Re: *Invenergy Docket No. SB-2015-06*

**INVENERGY THERMAL DEVELOPMENT LLC'S RESPONSES TO
THE RHODE ISLAND DEPARTMENT OF ENVIRONMENTAL MANAGEMENT'S
FIRST SET OF DATA REQUESTS**

CLEAR RIVER ENERGY CENTER FUEL OIL UNLOADING AND STORAGE PRELIMINARY CONCEPTUAL DIAGRAM	
FILENAME	M1200-0FO-238926.dwg
SCALE	NONE
238926-0FO-M1200

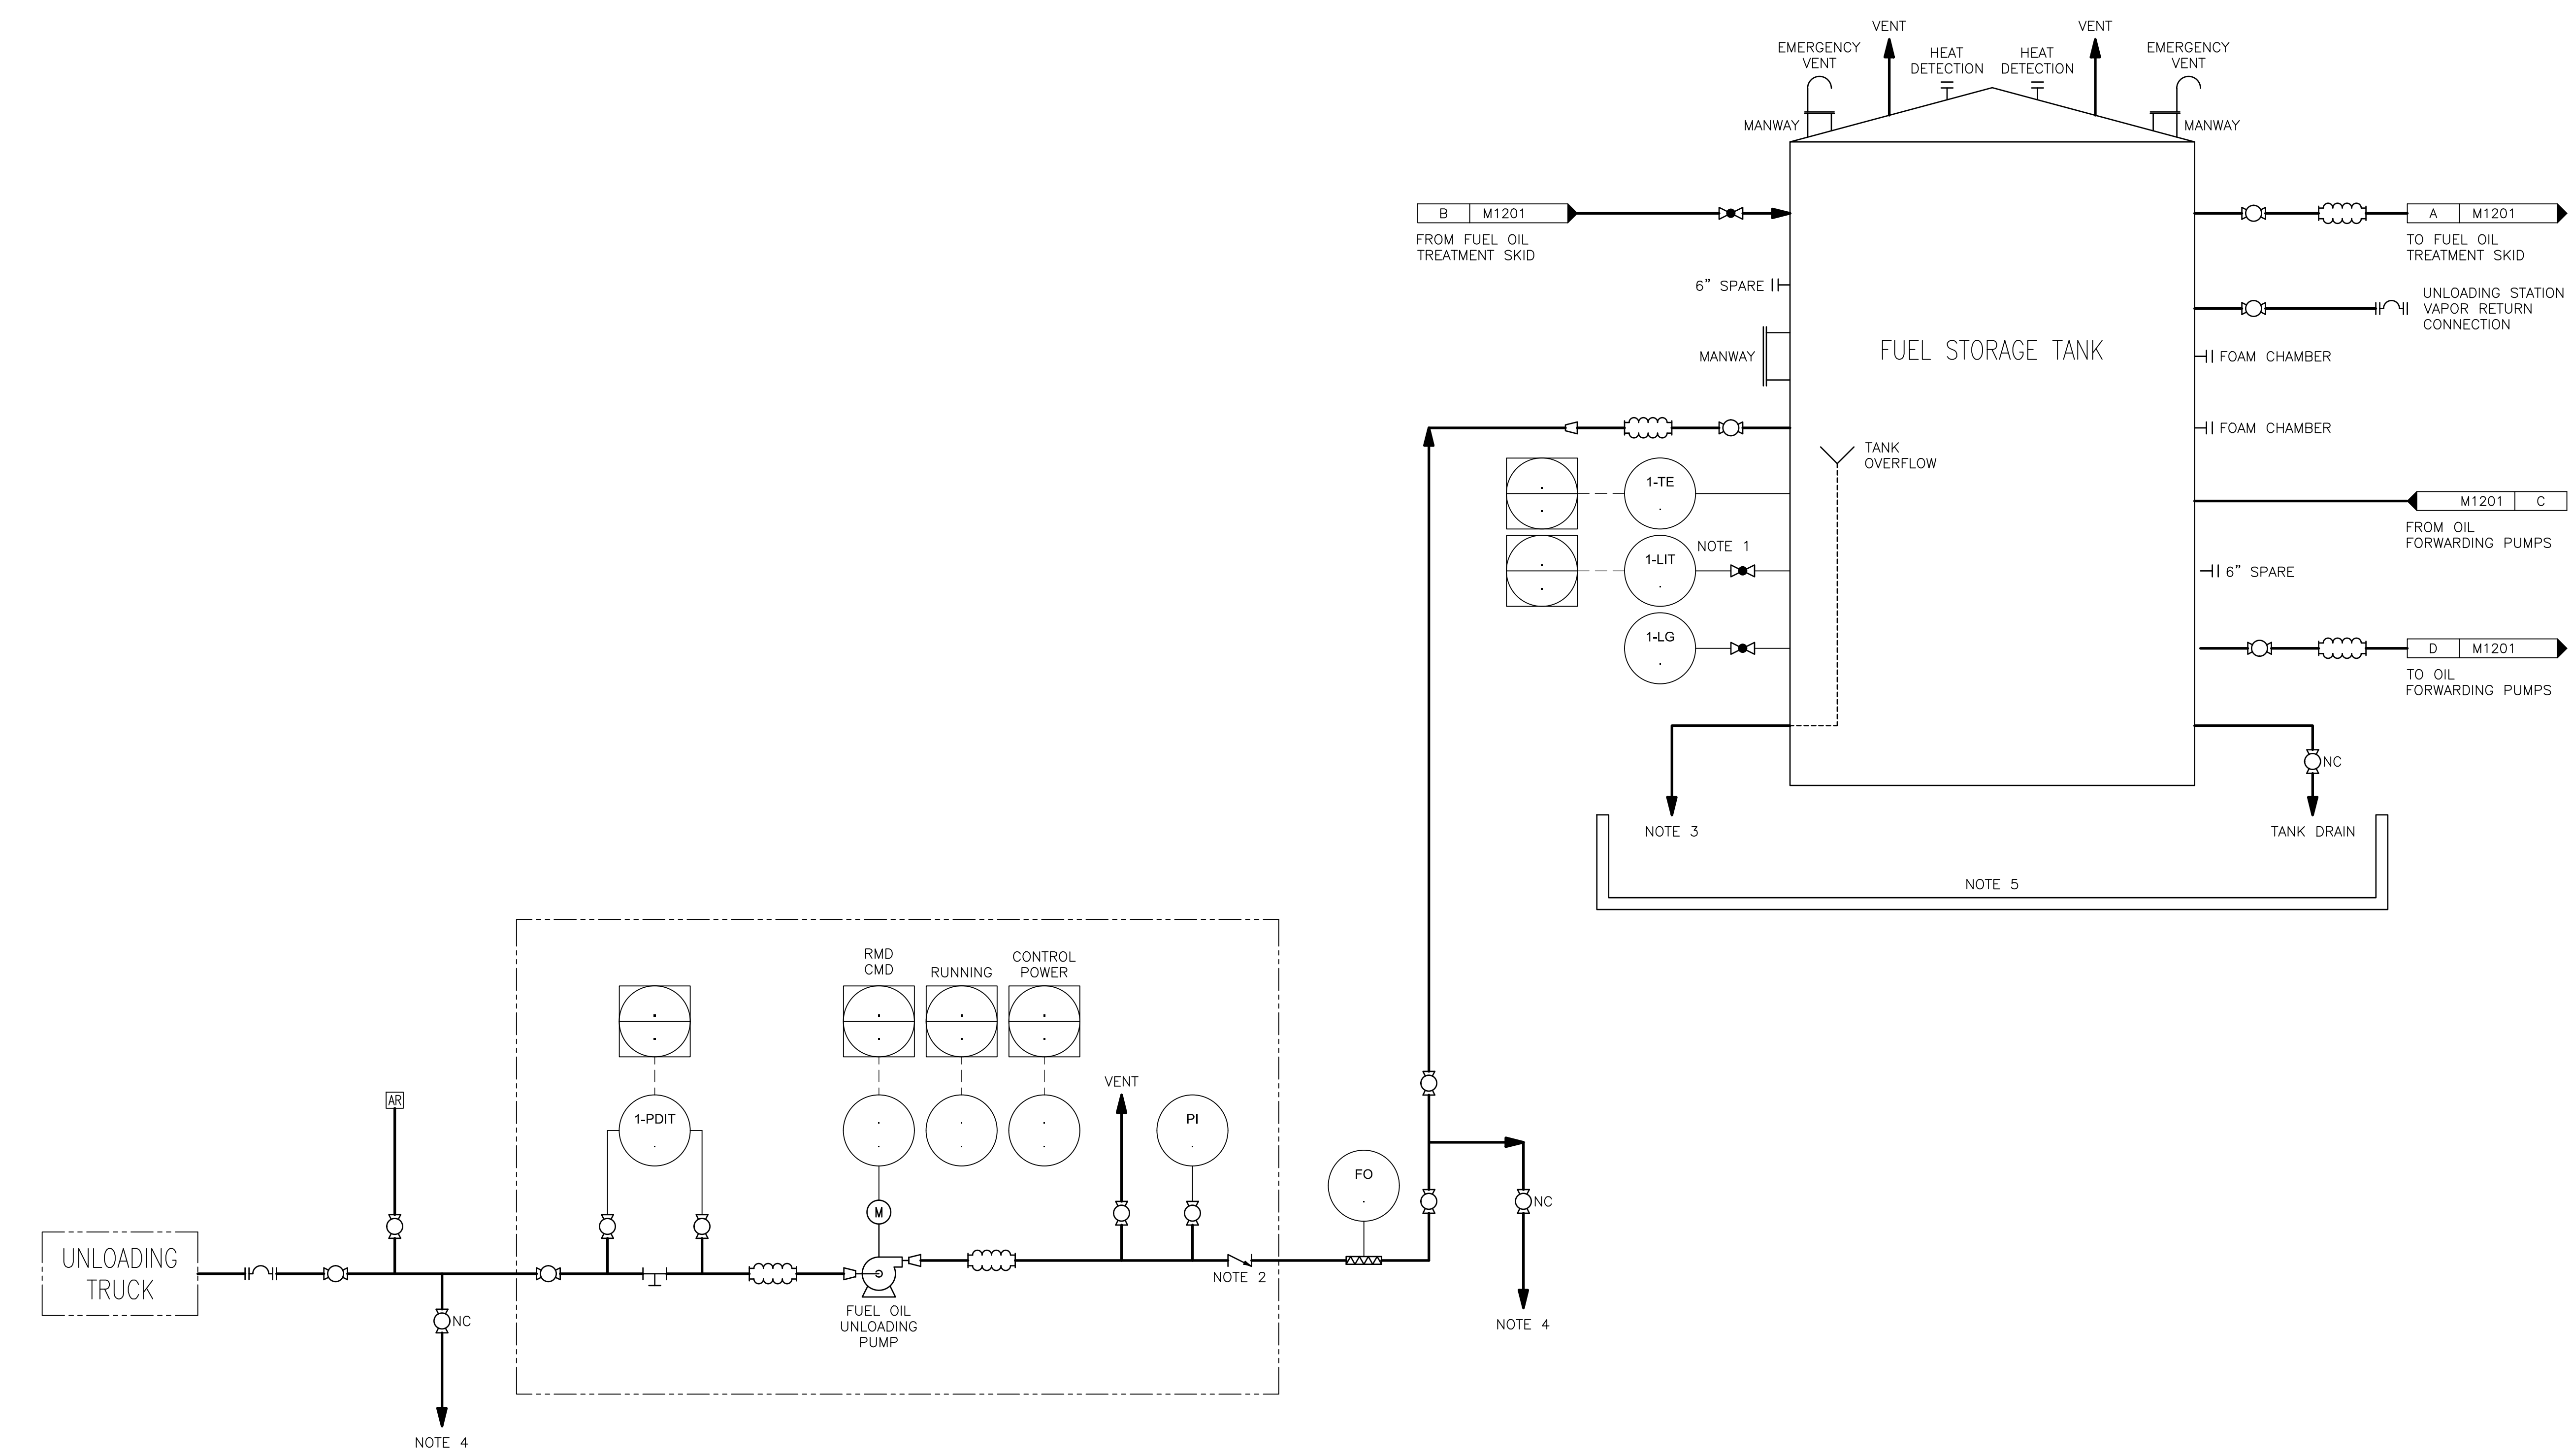
1-3 Please provide a diagram for any remote filled ASTs with a capacity of greater than 500 gallons that details the high level alarm warning system. *See OPC Regulations Section 9(b).*

1-4 Please provide a diagram that shows all regulated ASTs, fuel gages, piping connections and all appurtenances from the tank to the equipment burning the oil. *See OPC Regulations Section 10(b)(4).*

1-5 Please provide a diagram showing all check valves or equivalent device that provides automatic protection against backflow from the receiving tanks. *See OPC Regulations Section 10(b)(5).*

RESPONSE: 1-3: A preliminary conceptual design of the ASTs for the CREC is attached as **Exhibit 1**. The site layout at CREC allows the fuel oil delivery trucks to park in close proximity to the ASTs. A local unloading station will be utilized to pump oil from the delivery trucks to the ASTs.

The ASTs will be furnished with redundant level transmitters that will alarm both locally at the unloading station and remotely at the operations control room if a high oil level in the tank is attained. The high level alarm signal will automatically stop the unloading station pumps.

RESPONSE: 1-5: The fuel oil unloading pumps discharge line will be furnished with a check valve to provide protection against backflow of oil from the fill line and storage tank(s).

A preliminary conceptual design diagram of the AST(s) is attached as **Exhibit 1** and illustrates these features.

**CLEAR RIVER ENERGY CENTER
FUEL OIL SUPPLY PUMPS AND TREATMENT SKIDS
PRELIMINARY CONCEPTUAL DIAGRAM**

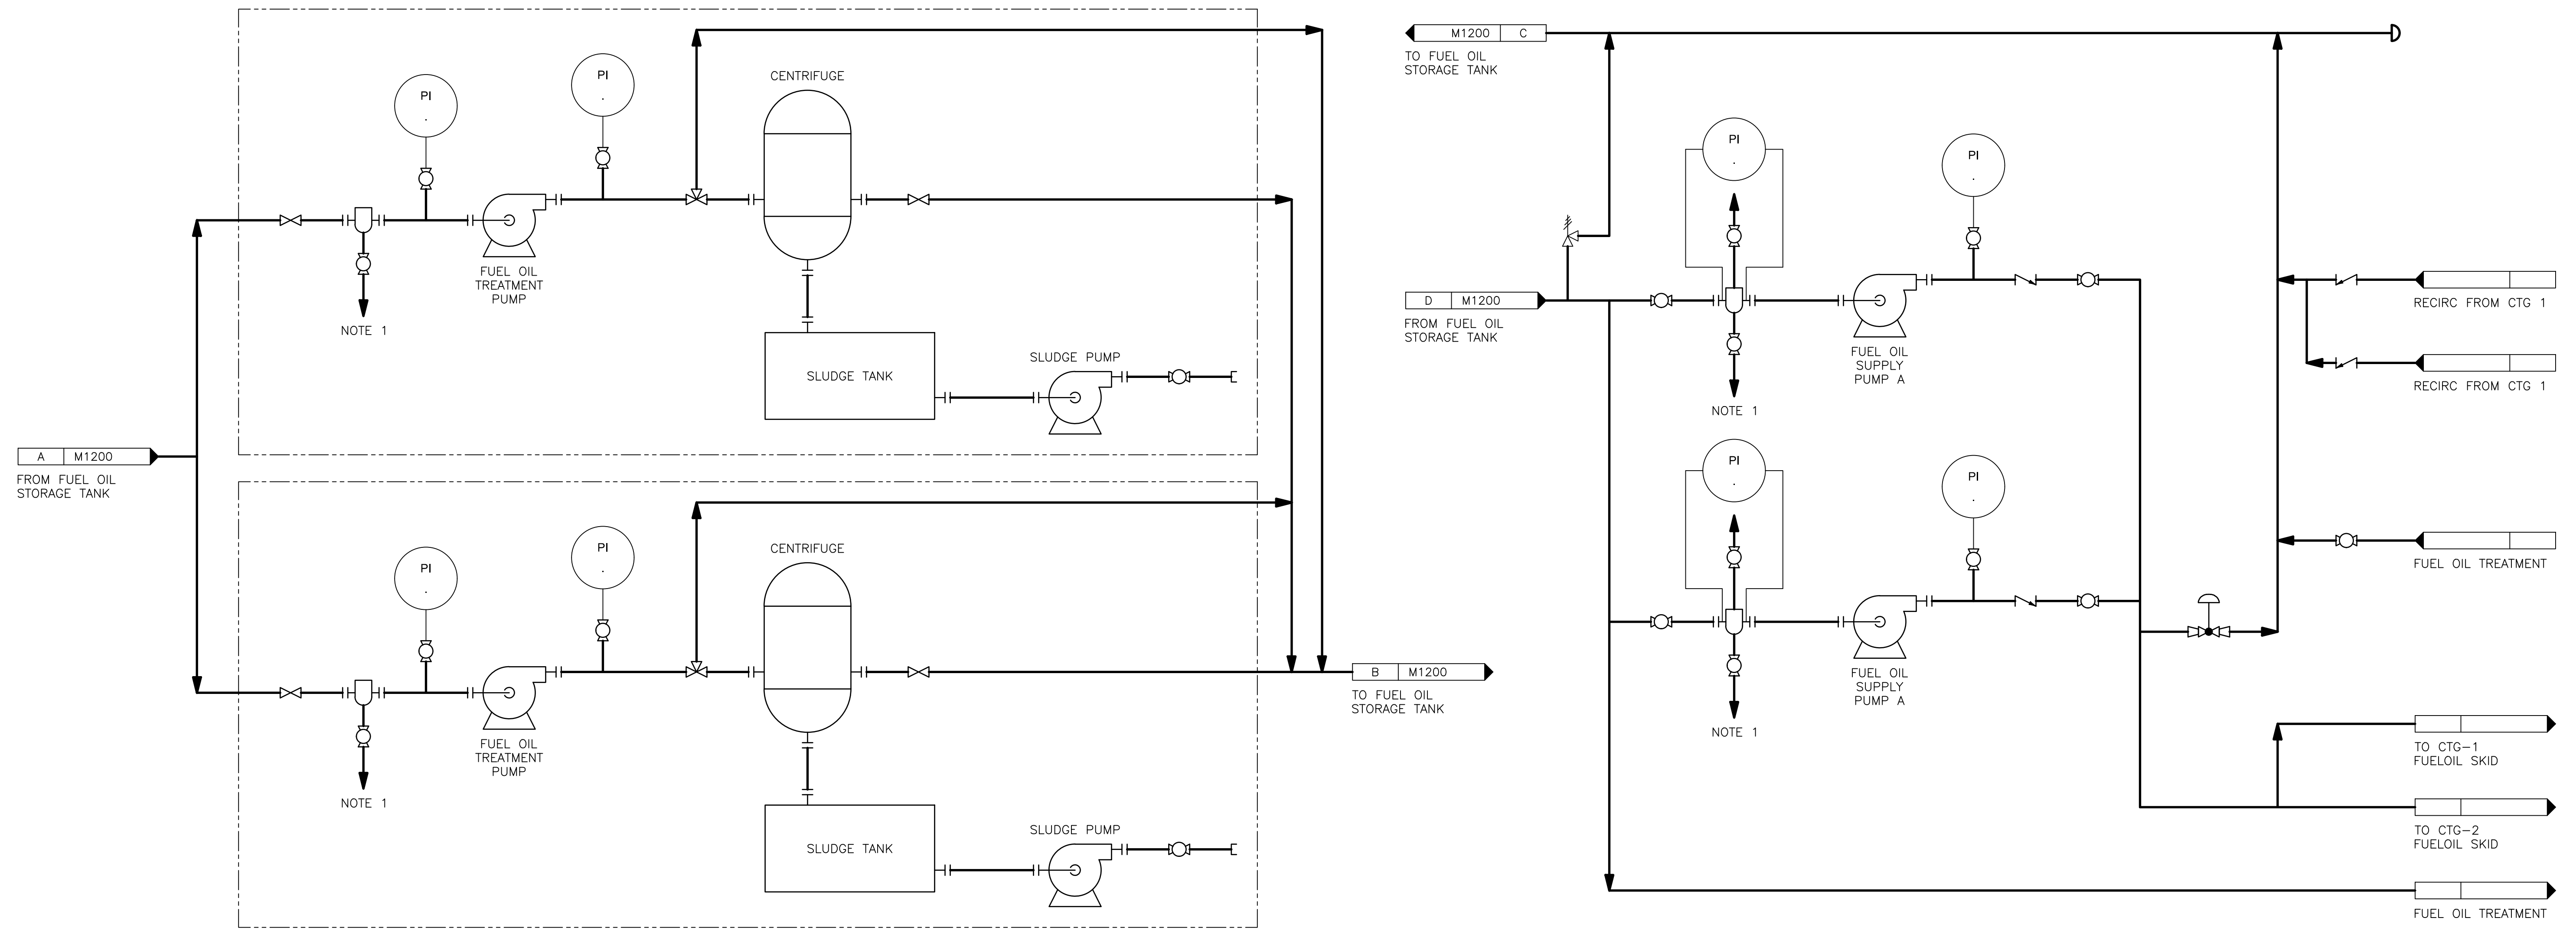
1-2 Please provide a diagram that details any boiler rooms that contain oil pipelines and floor drains. *See OPC Regulations Section 9(a).*

RESPONSE: 1-2: The CREC does not have a boiler room; however, there is oil supply piping from the fuel oil storage tank to the combustion turbine fuel oil combustion systems. A diagram of these piping systems is attached as **Exhibit 1**. The piping will be designed to prevent oil leaks by using double walled pipe where necessary and a leak detection system. The piping is routed to provide easy access to plant operators so that in the unlikely event of an oil leak, repairs can be made quickly preventing oil drips from accumulating in surrounding areas.
